**Subject: Comments on Lack of Demonstration of a Sustainable Water Supply,
Agenda Item 6.12 Board of Supervisors Meeting Tuesday July 14, 2026
Proposed Expansion of Pasta Farms 3 Cannabis Cultivation Operation, 10750
Siegler Springs Road, Kelseyville
Major Use Permit Application PL-26-115 and MND,**

Following a summary of my main comments below, this letter provides detailed technical comments on portions of the Staff Report dated June 11, 2026, the Water Availability Analysis dated January 13, 2025 and Appendices (Exhibit A5 to the Staff Report), and also the required CEQA process based on my review, experience, and expertise.

Figure 2. Hydrographs Showing Water Levels in Project Wells 1 and 2

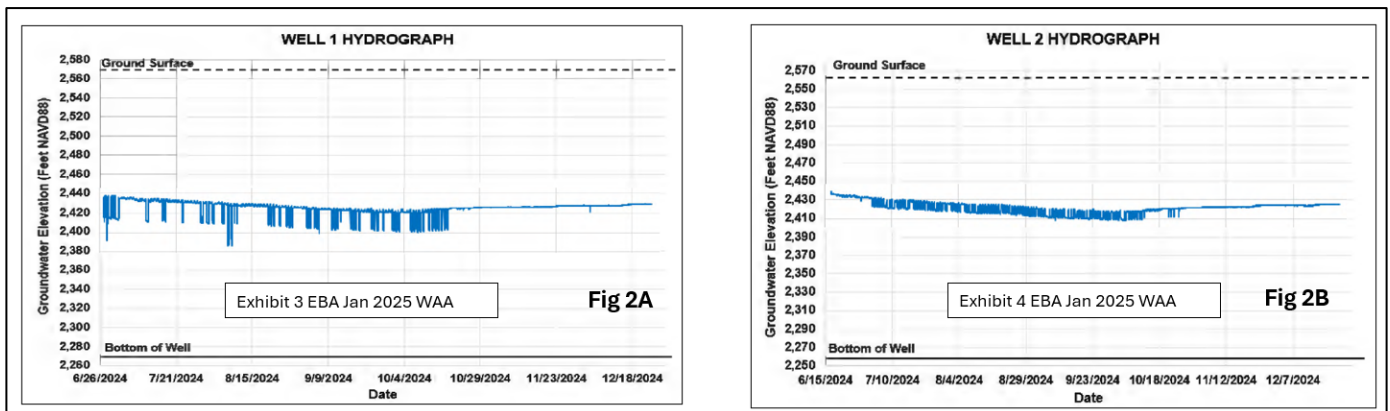
The Water Availability Analysis by EBA Engineering dated January 13, 2025 (EBA Jan 2025 WAA, Exhibit A5 to the Staff Report) includes water level hydrographs (Exhibit 3 and 4 on pages 21 and 22) that present monitoring data recorded in Project Wells 1 and 2 from late-June until mid-November 2024, which includes intermittent pumping for irrigation during the growing season. These two hydrographs are provided as **Figures 2A and 2B** below.

Unfortunately, the pumping rate data and/or total volume pumped with time at each of the two wells, which would facilitate analysis of the hydraulic properties of the fractured rock aquifer, are not provided. Nonetheless the monitoring data clearly document decreasing trends of water levels in the two wells and incomplete recovery to pre-pumping water levels when pumping is terminated after the irrigation season.

EBA states (Jan 2025 WAA, last bullet of the Conclusions Section, pg 23): “Groundwater elevations in Well 1 and Well 2 declined approximately 17 and 21 feet, respectively, from June through October, and gained back approximately 9 and 10 feet, respectively from October through December under non-pumping conditions.” Slightly different changes in groundwater level are estimated from the zoomed-in versions, which include a shorter duration of the data after pumping stopped. The estimates are provided for both versions in **Table 1**, below. Approximately 1month after pumping stopped, the recovery is 25% to 33% of the decrease in during the irrigation pumping period. And after an additional month without pumping, the recovery is approximately 50% of the decrease in during the irrigation pumping period. **In all cases the recovery is far less than 95% of the decrease during the period with pumping.**

Figure 3. Zoomed-In Hydrographs Showing Water Levels in Project Wells 1 and 2

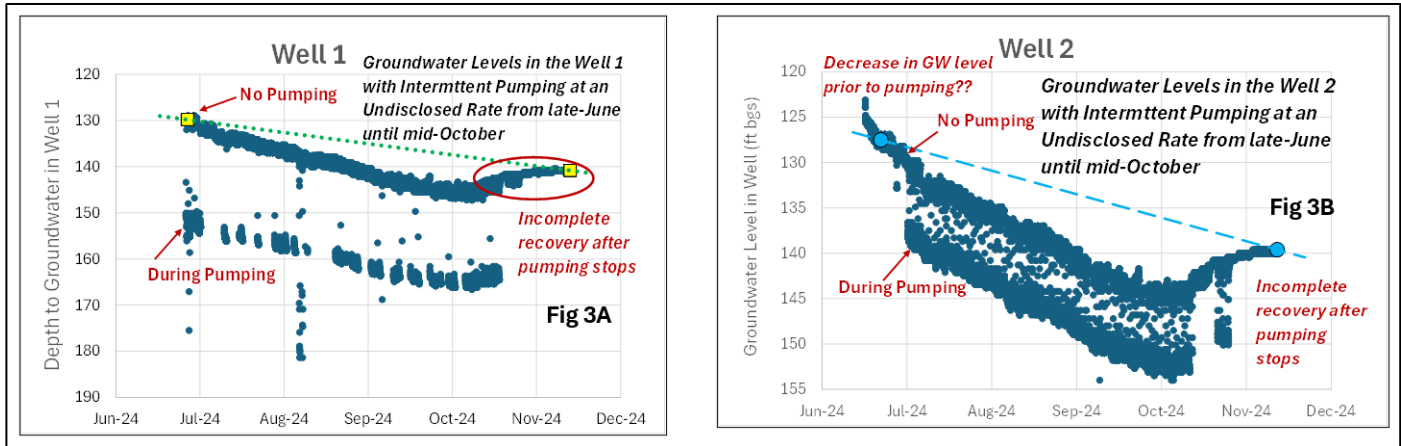
Figure 3A and 3B, below, are zoomed-in versions of the same water level data, which was provided by the Applicant, with annotations and trend lines, are inserted below.

The trend lines of the groundwater levels included on **Figures 3A and 3B**, above, which are fitted to the non-pumping water levels at the start and of the irrigation season and after ~one month of recovery when pumping was terminated, are extrapolated forward in time beyond June 2028 on **Figure 4**, below. Assuming similar pumping each irrigation season, **the extrapolated linear trends show groundwater levels dropping below the top of the well screens in Well 1 and Well 2 in 2028 and 2026, respectively.** As the groundwater levels drop below the top of the well screens, the yields of the wells are likely to decrease, and the groundwater levels are likely to drop more quickly.

Figure 4. Extrapolated trendlines of groundwater levels recorded in Wells 1 and 2 during 2024 (see Figure 2A and 2B, above)

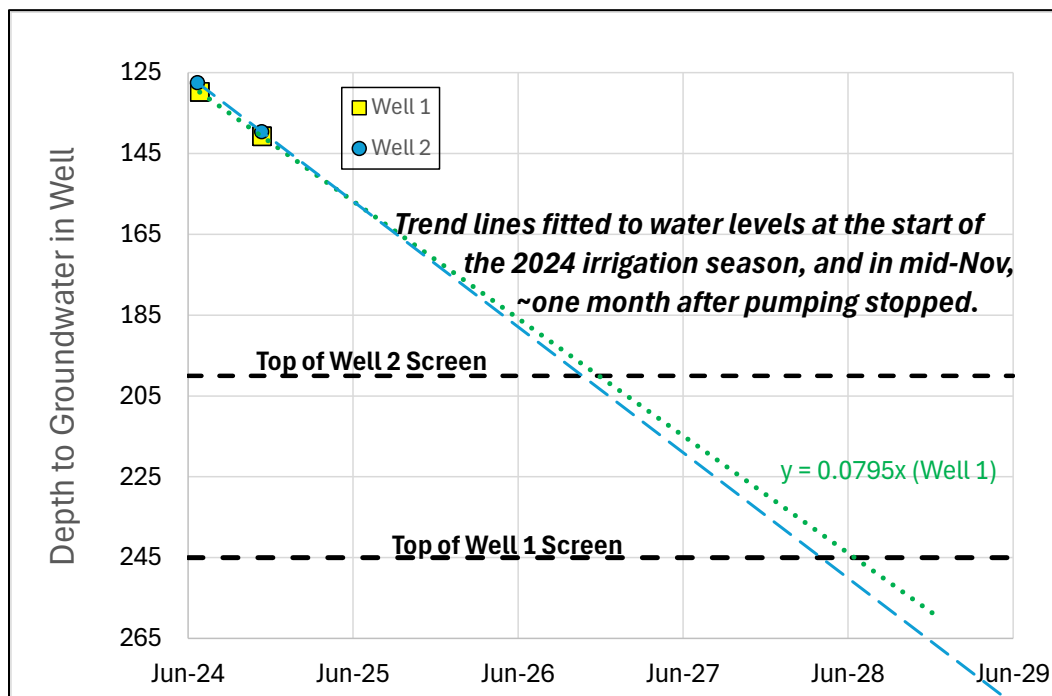
Additional water level data for Wells 1 and 2, such as for 2025 would be helpful and facilitate refinement of this analysis. Also, operational data from other wells that have been used during several previous years of operation of the Pasta Farms Facility would be helpful.

Figure 5. Well Density Map

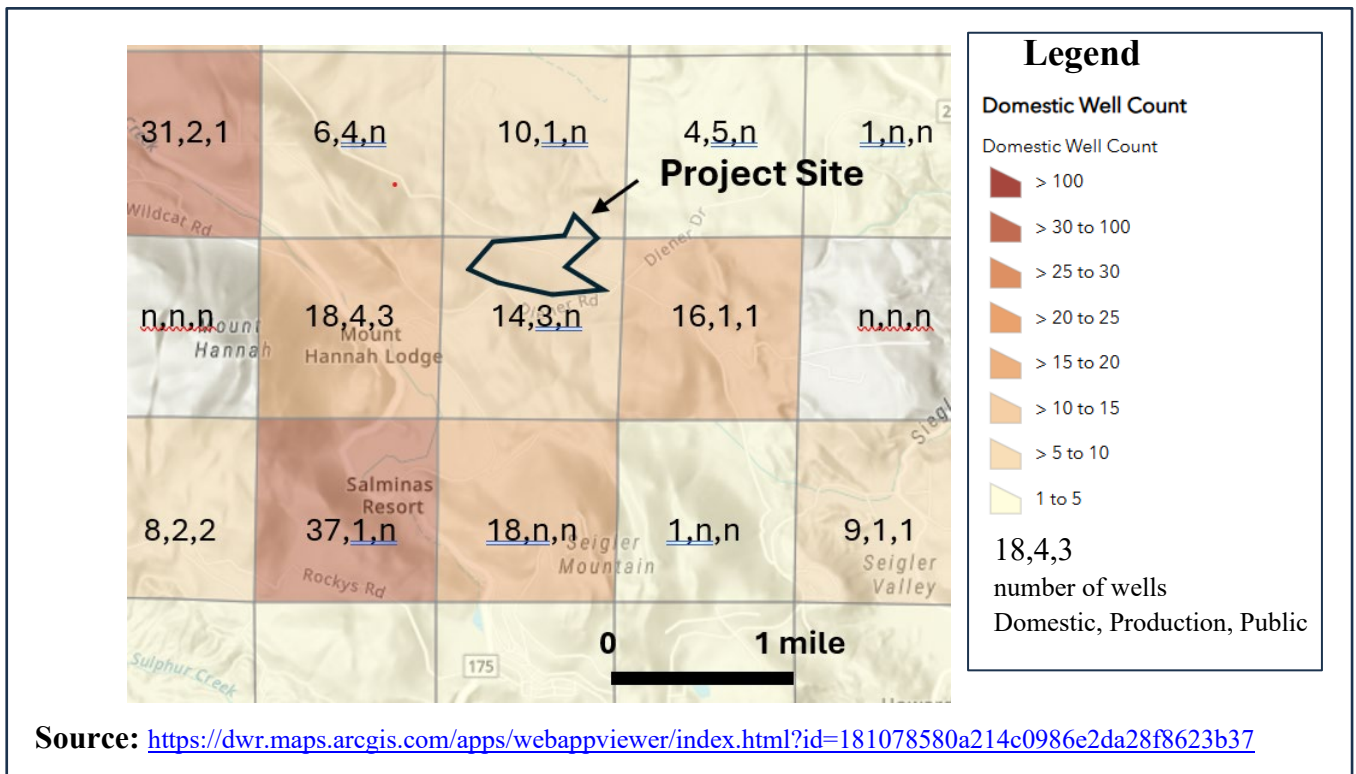
Most importantly, the calculation of extent of influence of pumping is based on only 515 minutes (8.6 hours) of pumping, which would be the daily duration of pumping from the two project wells to meet the maximum daily demand during the irrigation season. Accordingly, as stated on page 20 of the EBA Jan 2025 WAA, **“the analysis assumes 95 percent recharge [recovery] in the respective wells before initiating the next pumping cycle.” But, as clearly documented by the water level monitoring data presented above, this assumption is not valid.** The cumulative influence of pumping cycles and potential impacts to the numerous wells in the general area must be considered. **Figure 4**, below, shows well densities in square mile sections in the vicinity of the Project Site.
